ADDENDUM NUMBER: TWO [2]

PROJECT: Provalus Whiteville

ARCHITECT'S PROJECT NO: 24002

DATE: November 27, 2024

DG Sheet Title REFLECTED CEILING PLAN

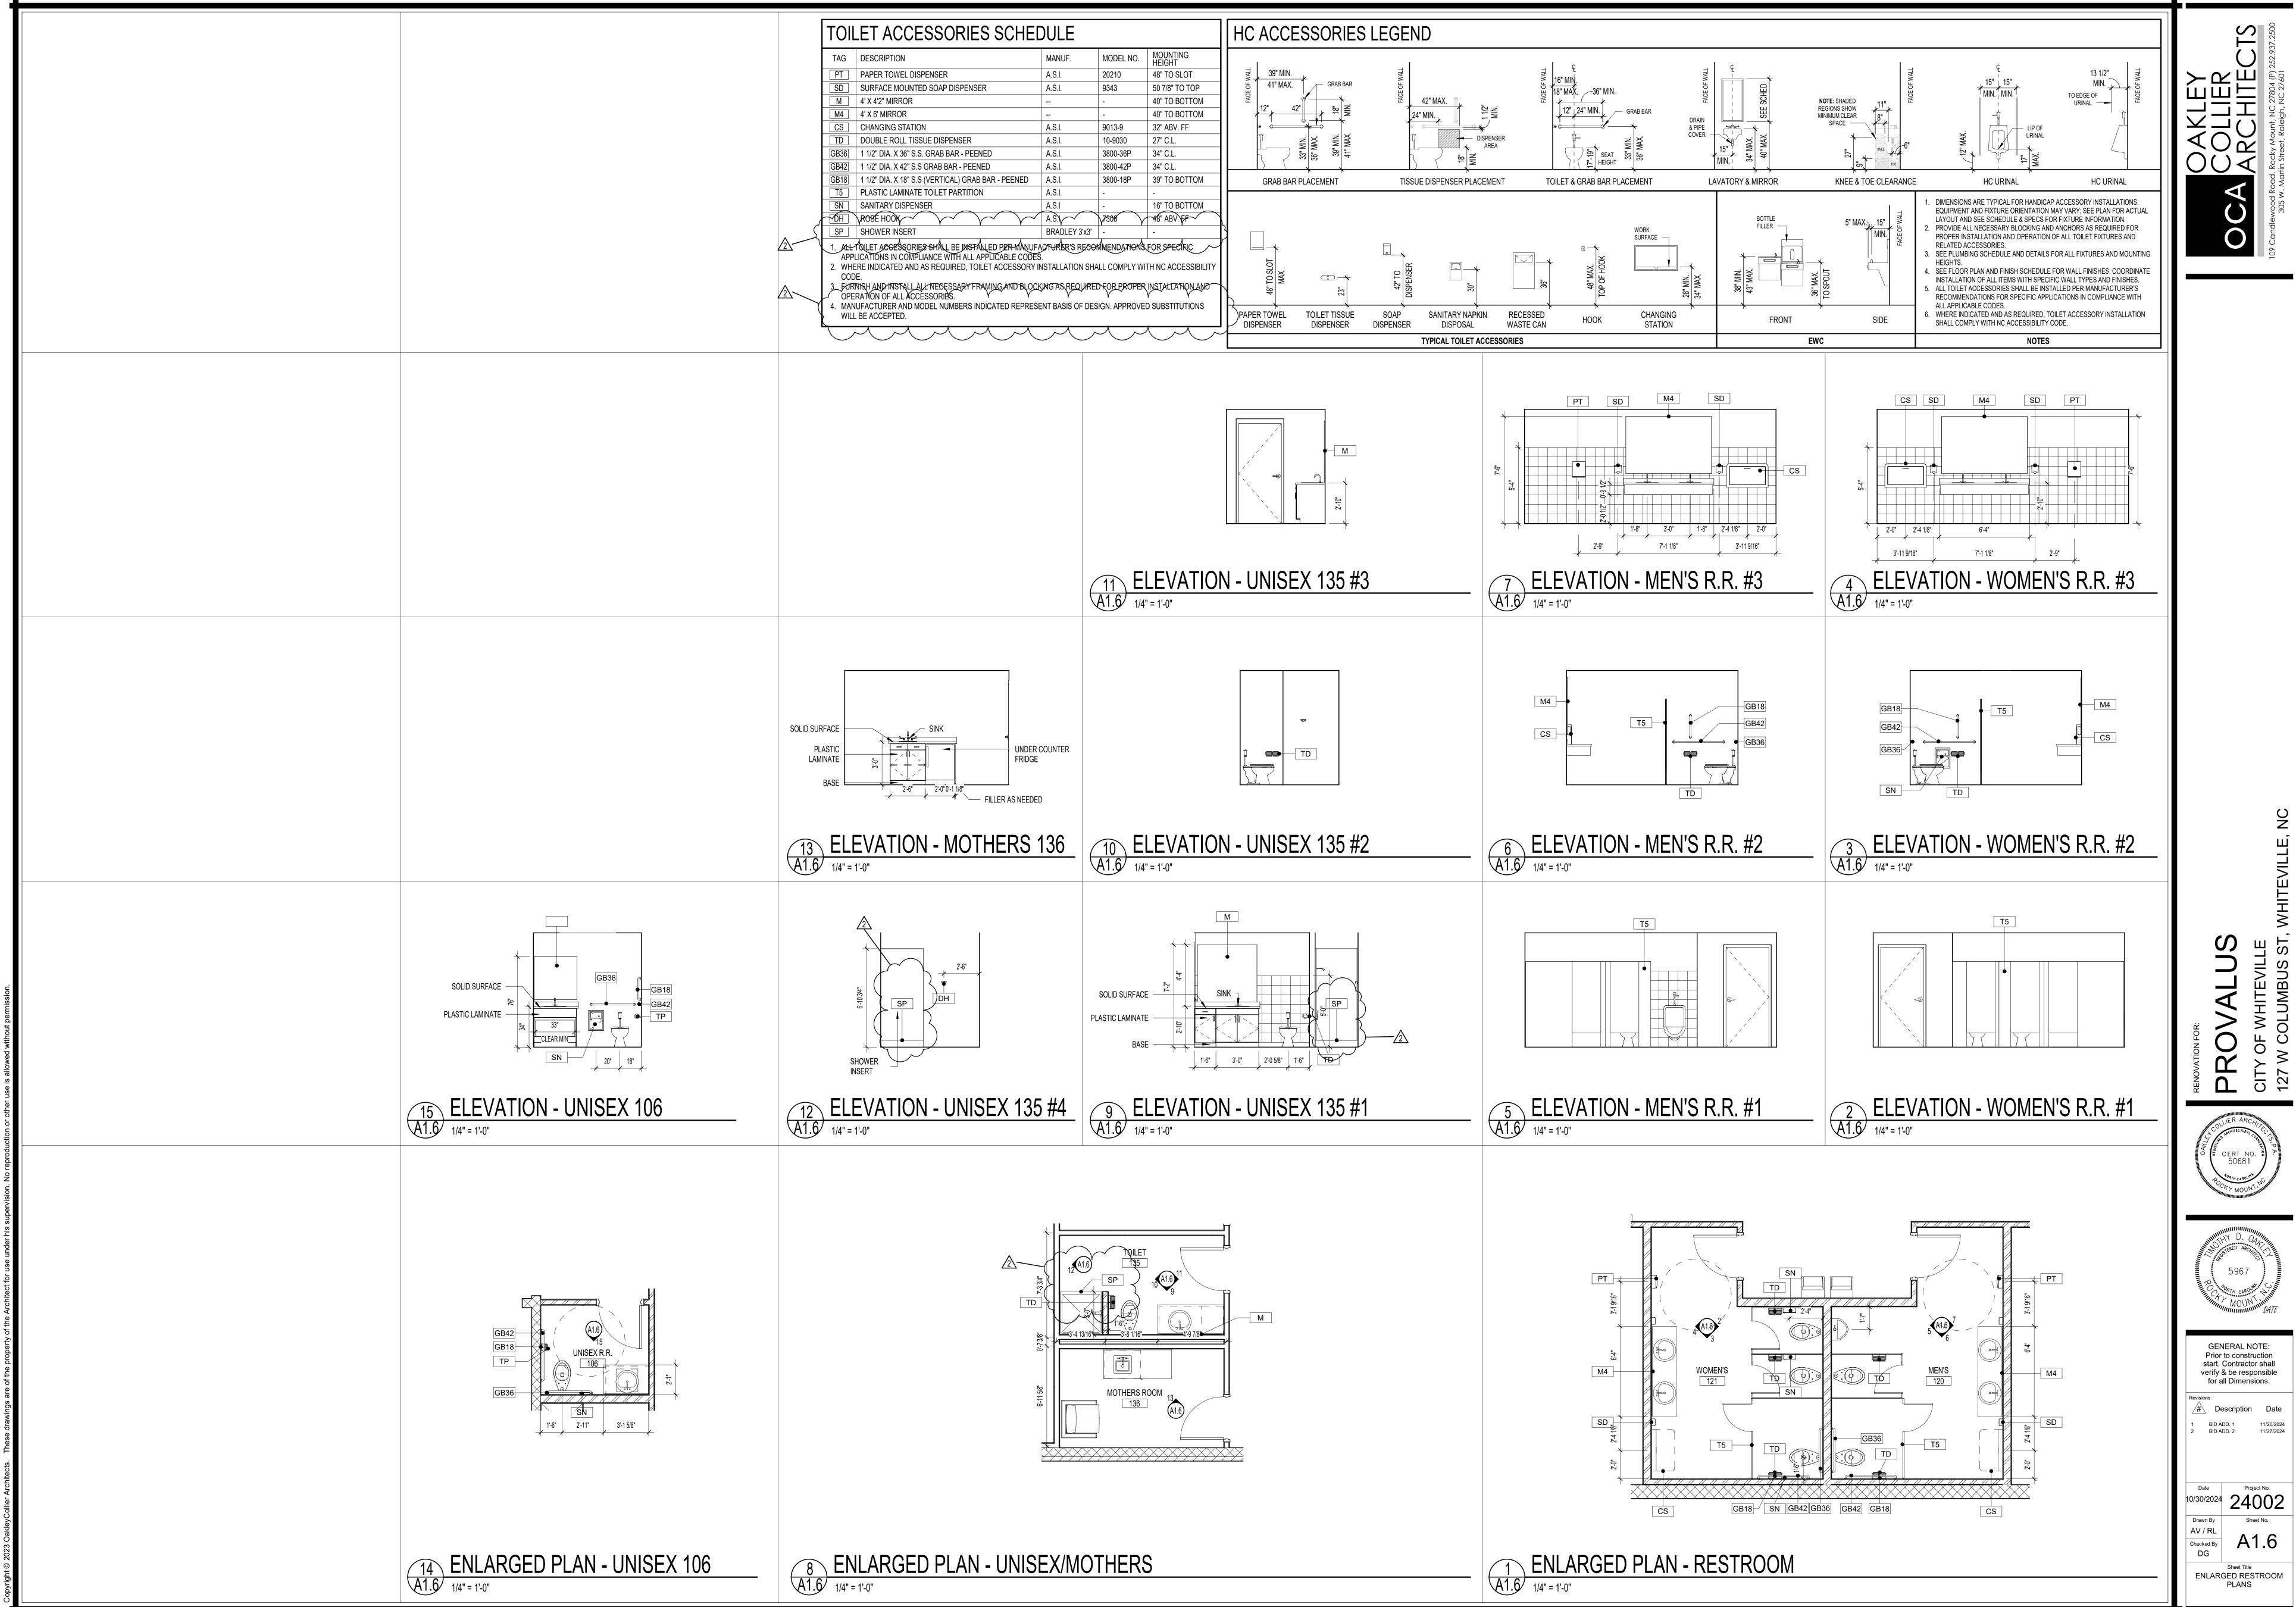
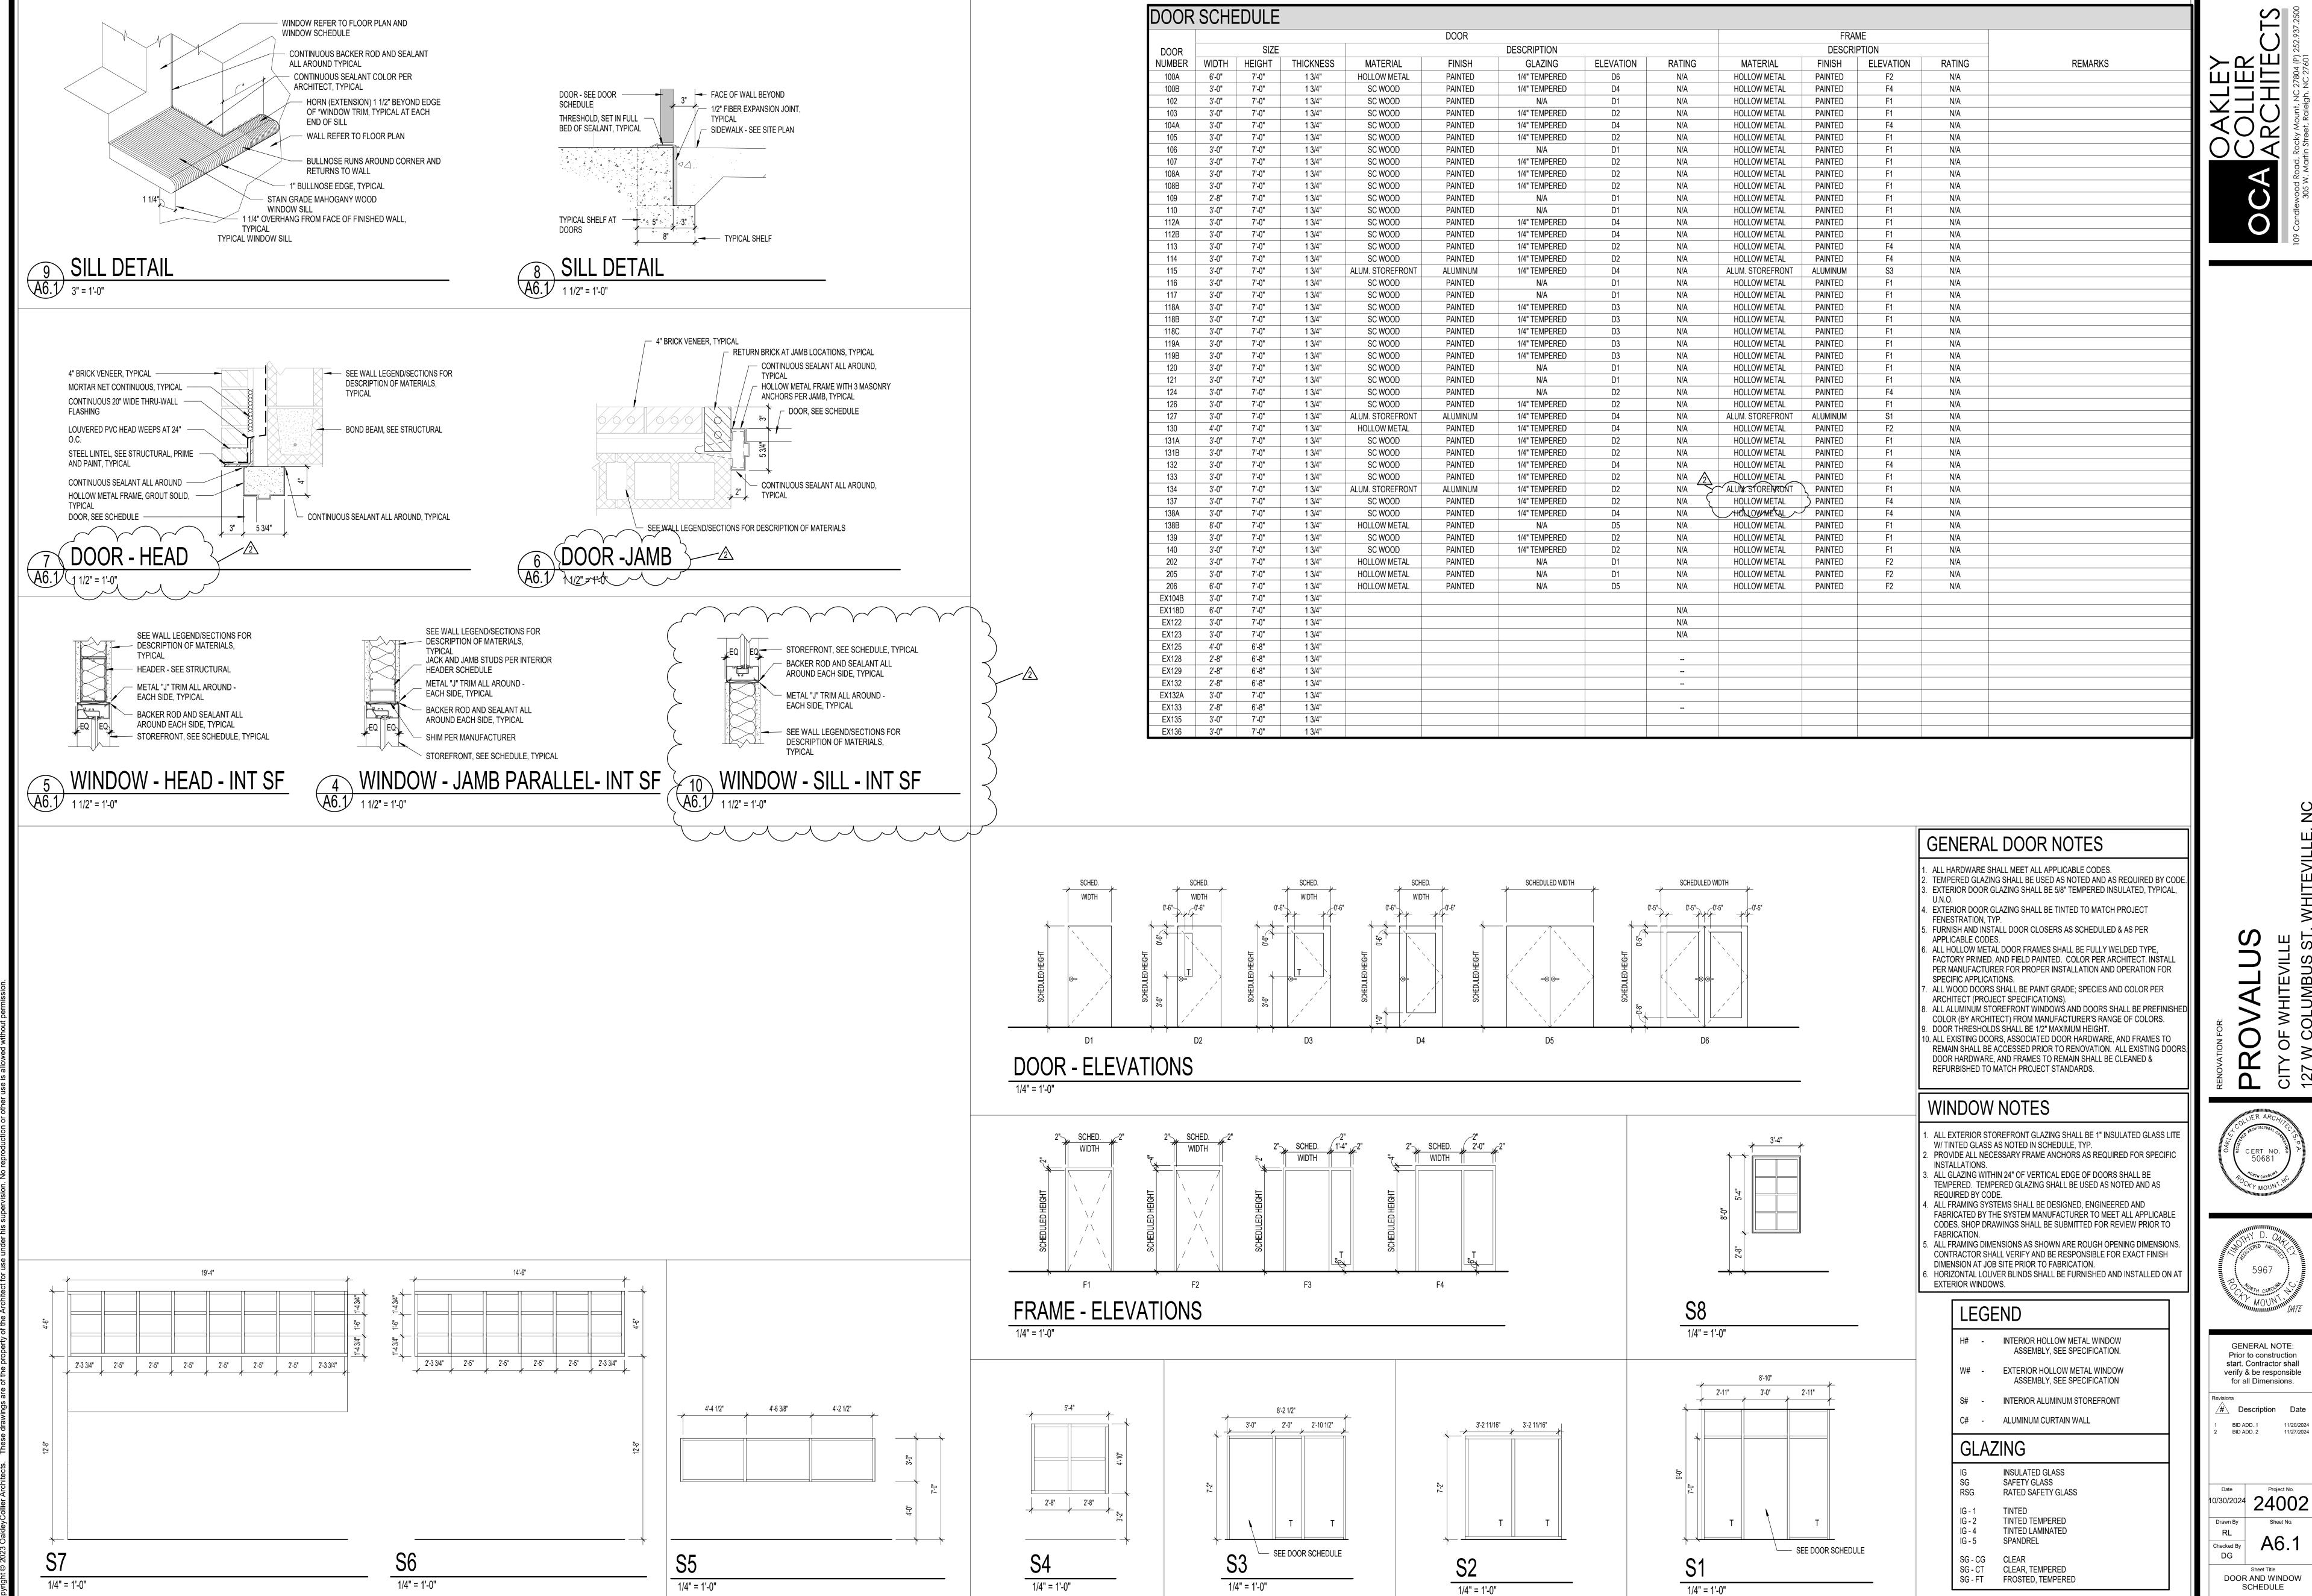
Item <u>3</u> Revision Sheet A1.2 – Reflected Ceiling Plan

Updated Ceiling Legend

Sheet Title DOOR AND WINDOW DETAILS

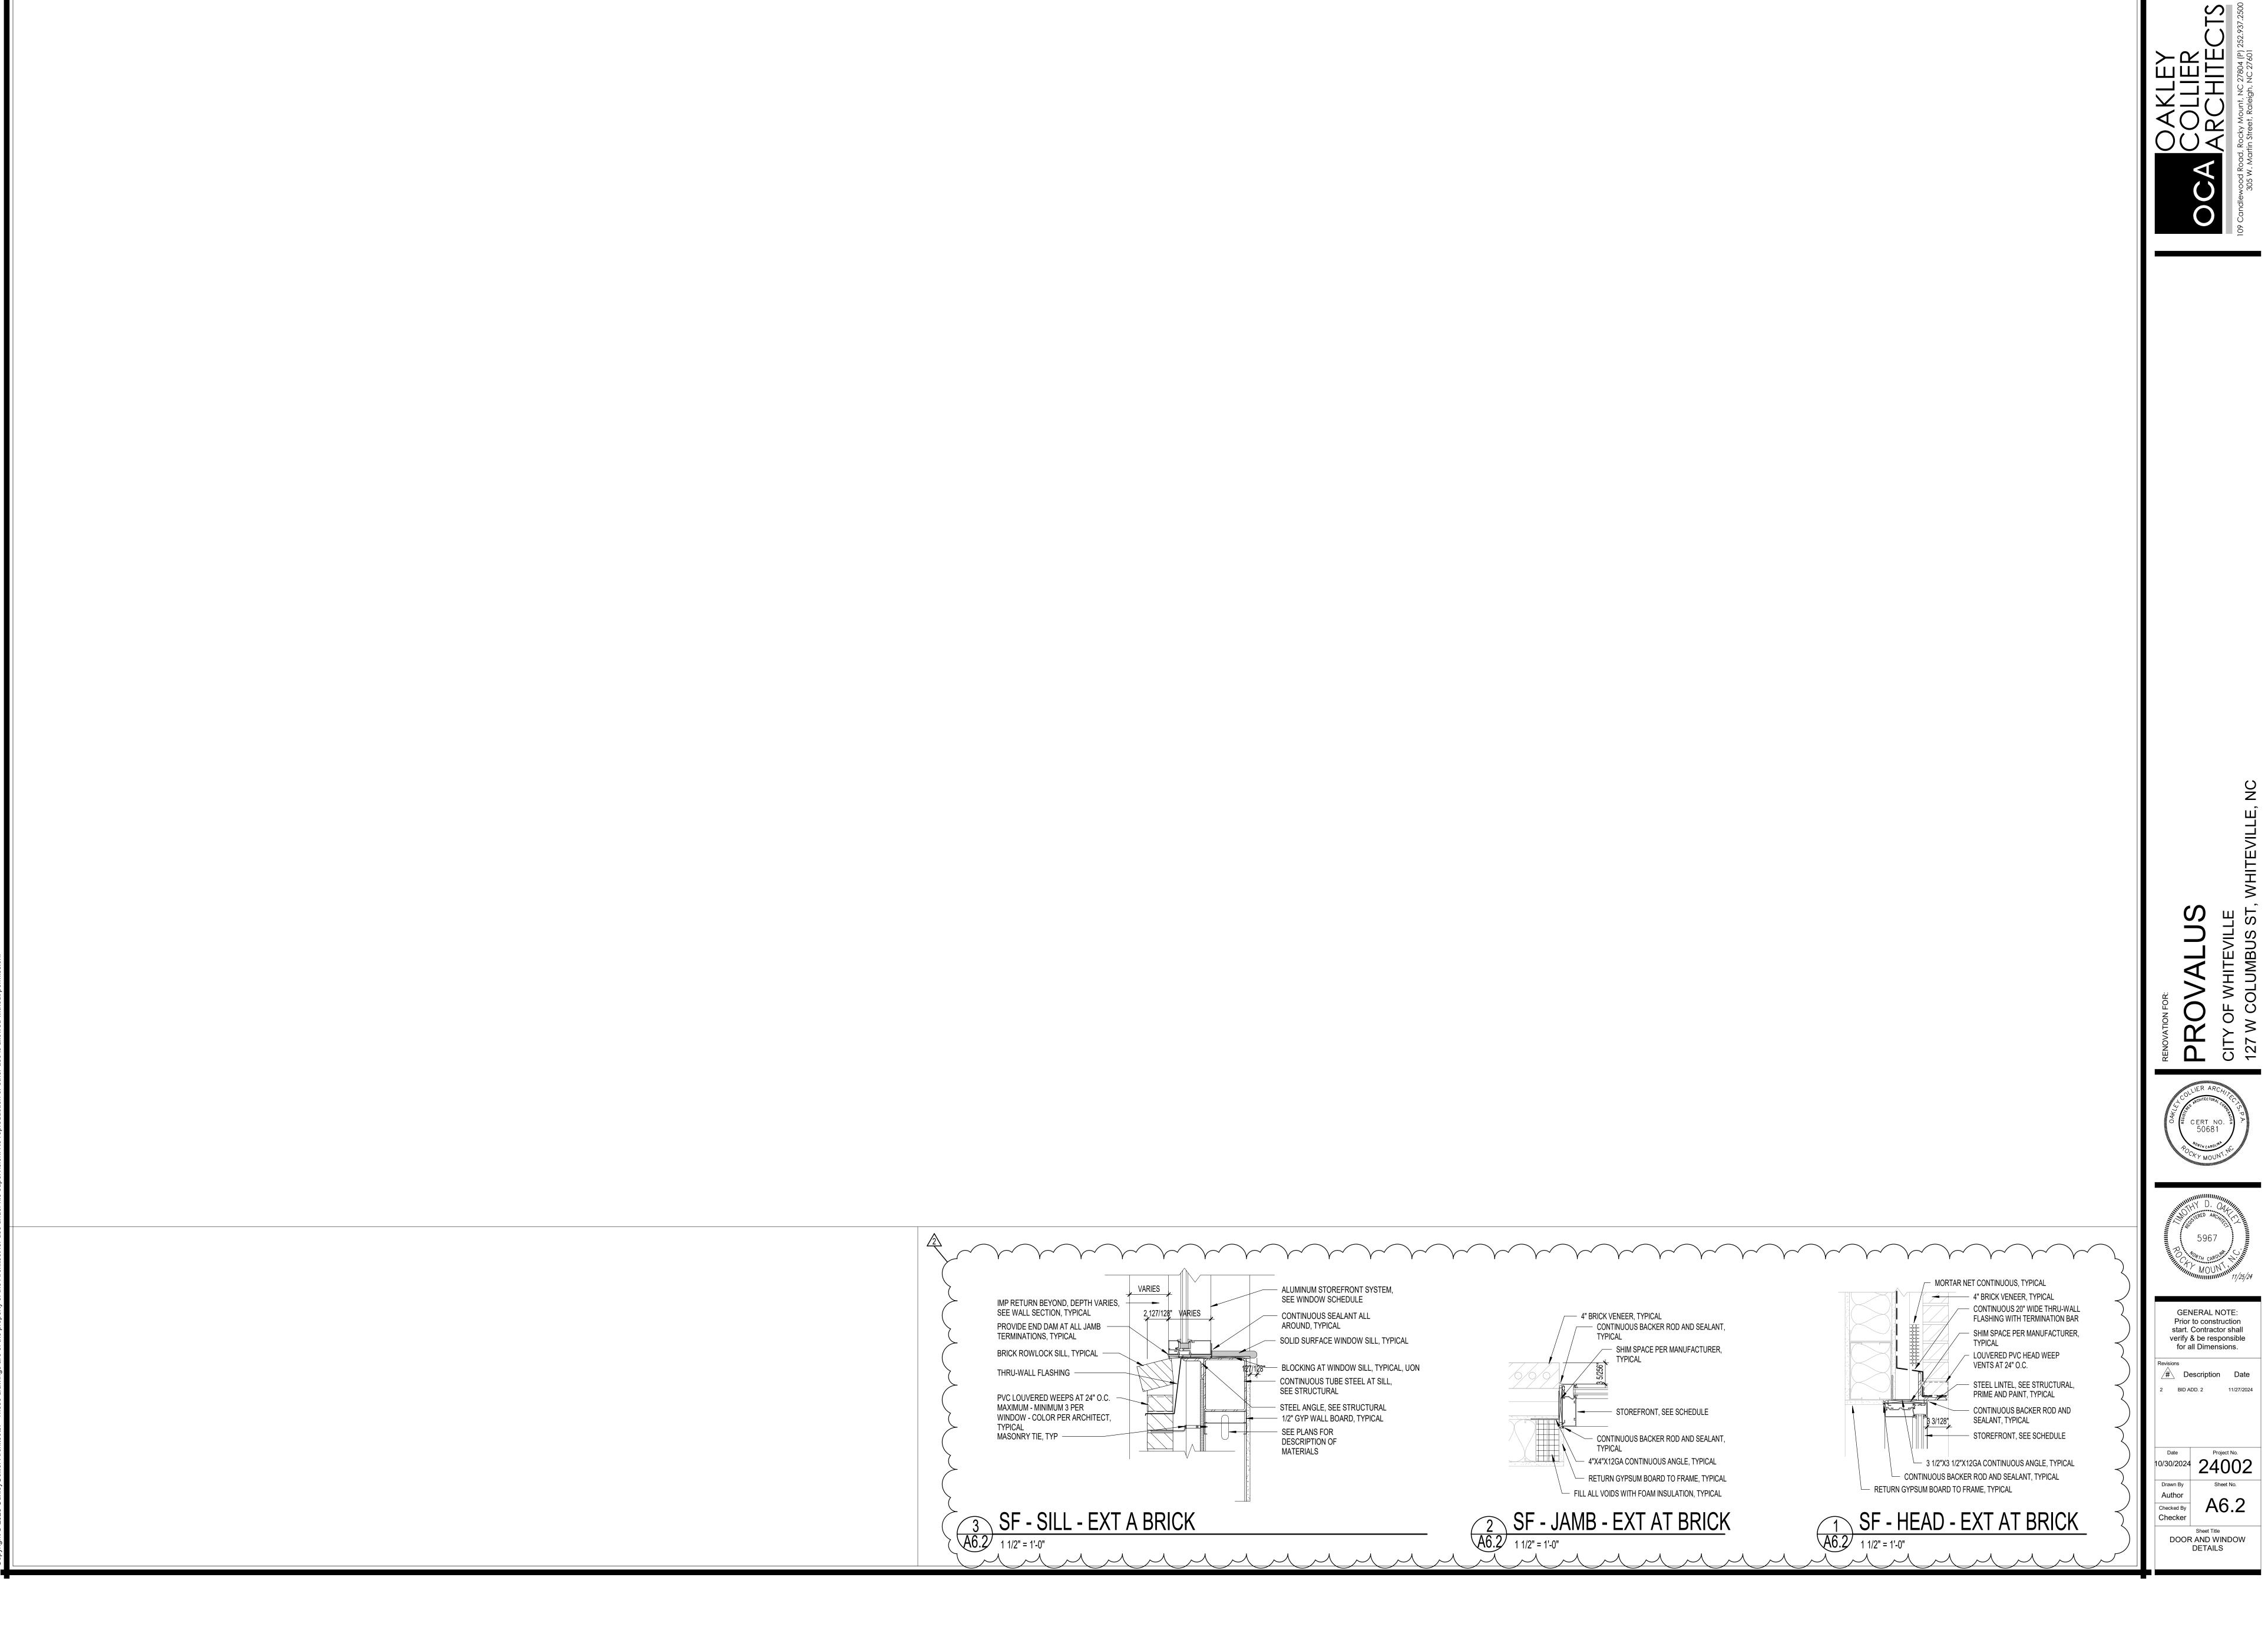
Item 7 Revision Sheet A6.2 – Door and Window Details

New Sheet Added, Includes details for Storefront details at exterior walls.
